NUMBER: 09-004-18

6.2L Knock Sensor Heat Shield Loose/Missing

This bulletin involves inspecting and if necessary, replacing the knock sensor connector back cover and installing a new heat shield.

2018 (WK) Jeep Grand Cherokee (Trackhawk)

Fig. 1
Sensor Locations

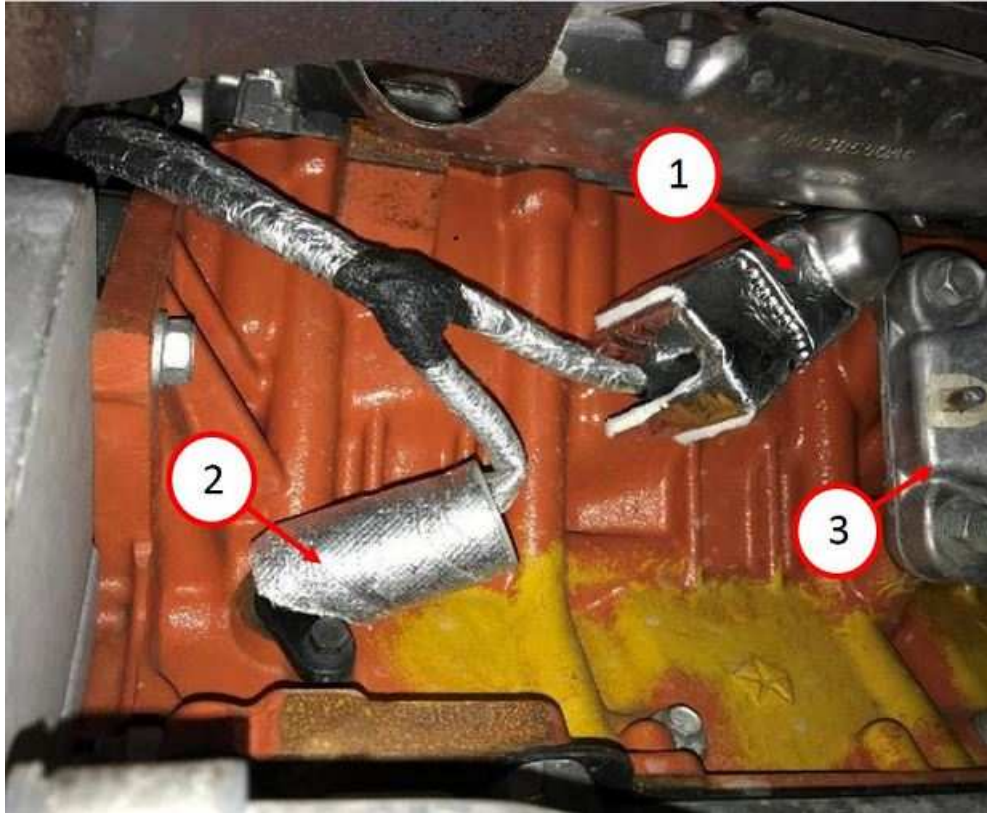
1. Raise and support the vehicle. (Refer to the detailed service procedures available in DealerCONNECT> TechCONNECT under: 04 - Vehicle Quick Reference/Hoisting/Standard Procedure).
2. With vehicle on a hoist, remove the heat shield and inspect knock sensor heat shield (Fig. 1) .

3. Was the knock sensor heat shield (Fig. 1) loose, missing or is there any damage to the harness connector back cover?
 - YES>>> Continue to the Repair Procedure. Proceed to [Step 1](#) of the Repair Procedure.
 - NO>>> This bulletin has been completed. Use inspection LOP (25-01-85-93) to close the active RRT.

Fig. 2

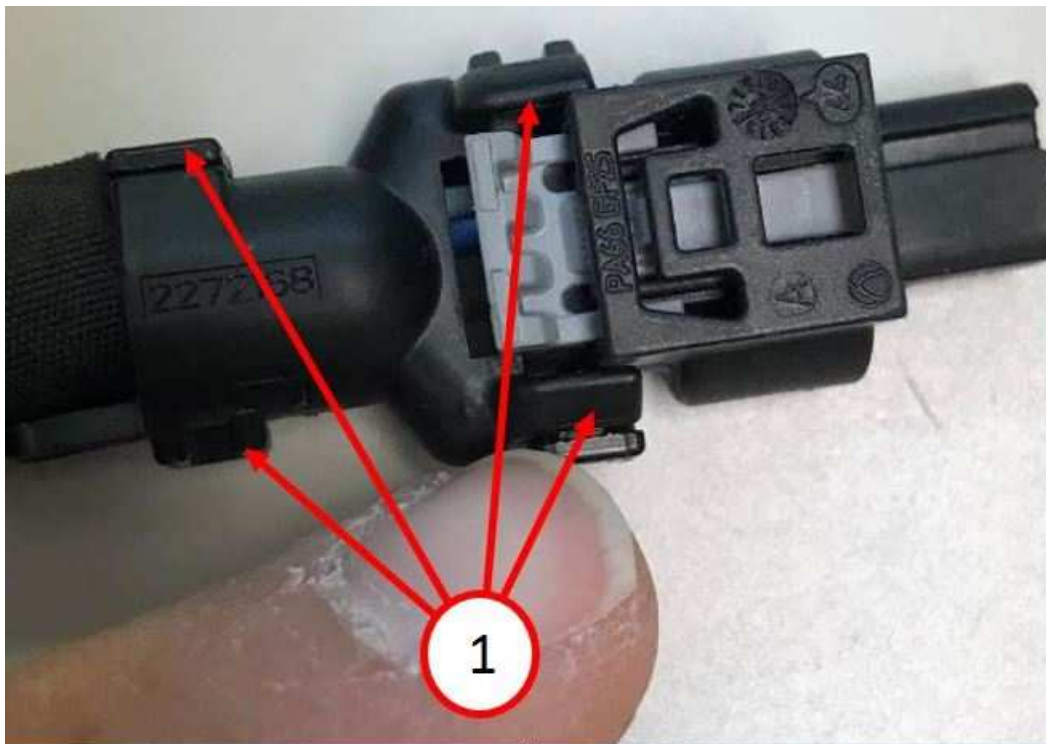
1. Remove knock sensor connector and crankshaft position sensor connectors, move branch rearward over the exhaust catalyst to ease removal of backshell. See (Fig. 1) for locations.
2. Remove the backshell from the knock sensor (Fig. 2) .

3. Install new backshell (P/N 7806995) on knock sensor (Fig. 3) .

Fig. 4
Crankshaft Position Sensor Heat Shield

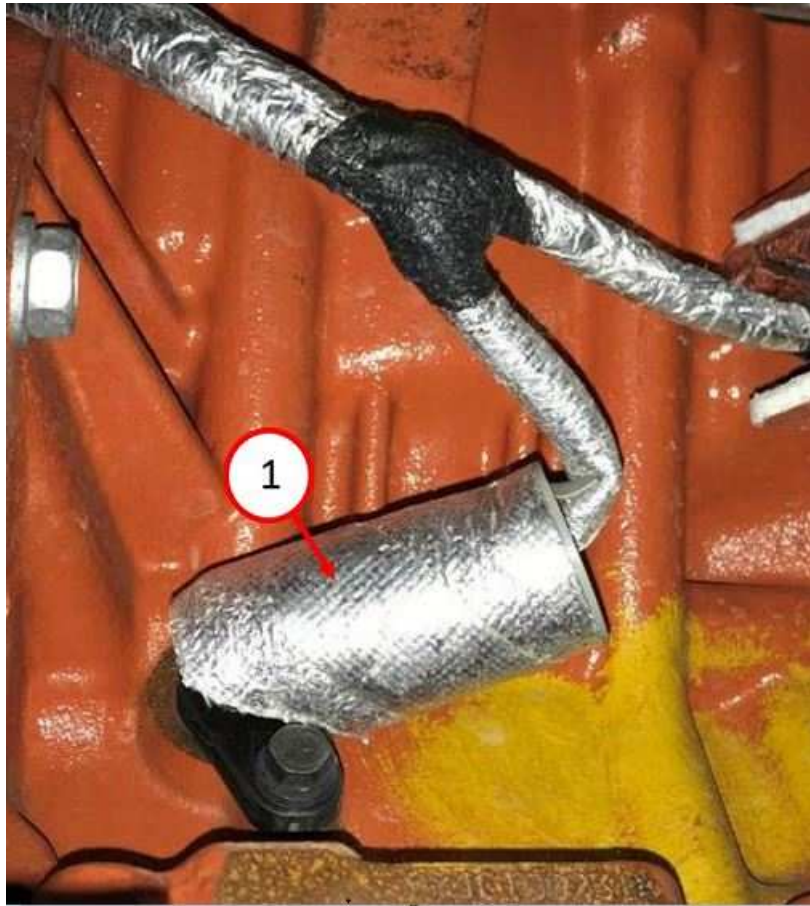
5. Reinstall the heat shield on the crank sensor (Fig. 4) .

Fig. 5
Knock Sensor Heat Shield

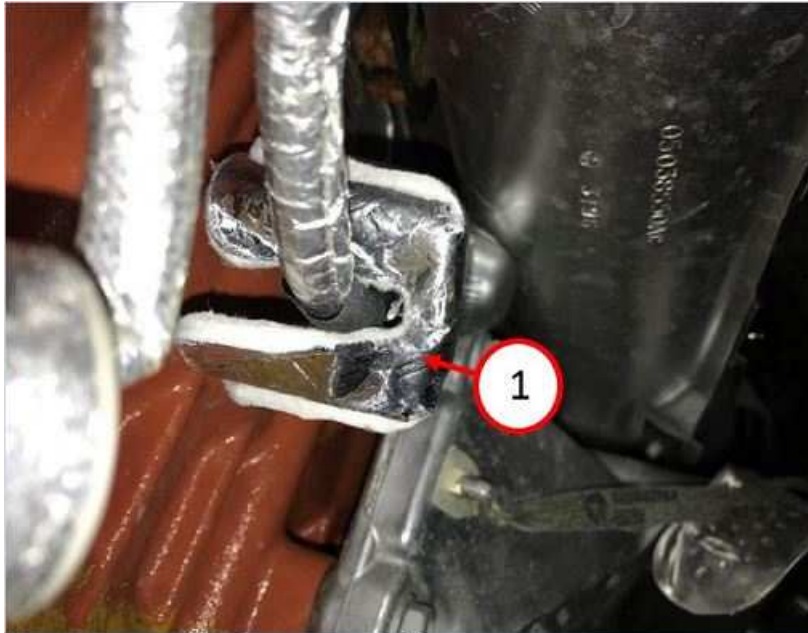
6. Install the knock sensor heat shield (Fig. 5) .

NOTE: Whether the heat shield is damaged or good, replace the heat shield with the new part provided.

- Press down toward the connector to clip the heat shield onto the connector cover. You should hear or feel it clip on.

Fig. 6

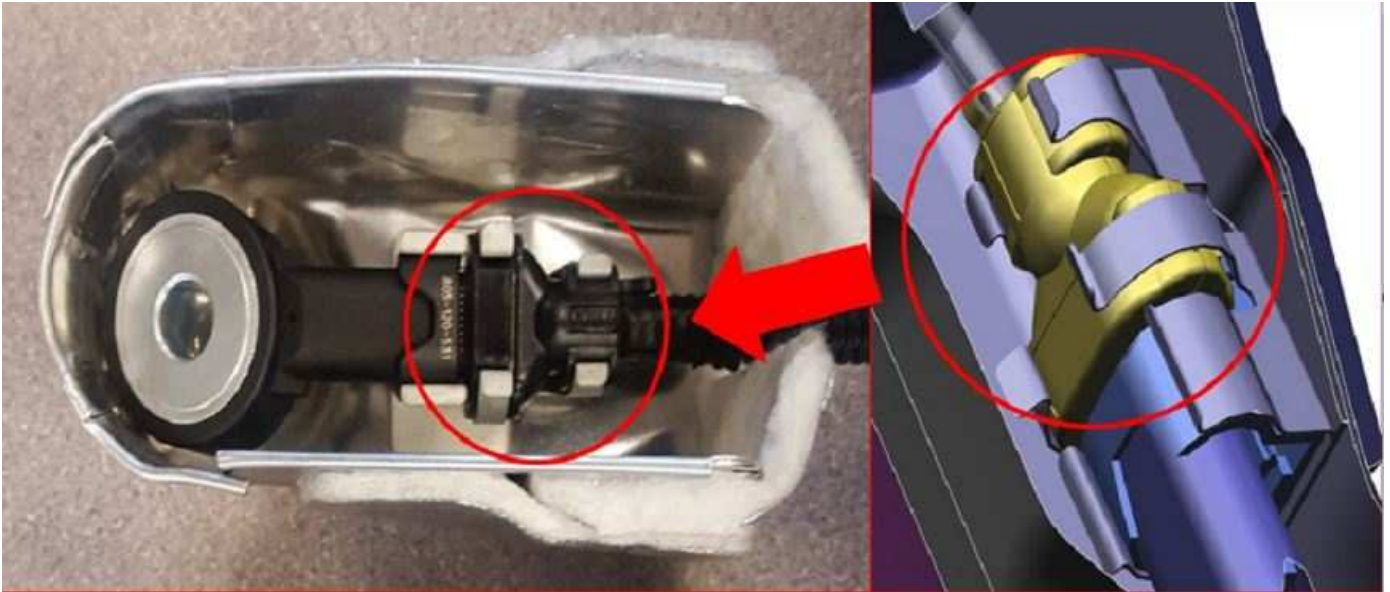
- Verify that the lower clips are fully engaged or use a flashlight to see the clip is secured on the connector backshell (Fig. 6) .

- Do an up or down motion on the heat shield on the connector/wiring harness axial direction to confirm the lower clip is in position.

NOTE: There should be a slight amount of movement allowed. About 1 mm to 1.5 mm (1/16 inch).
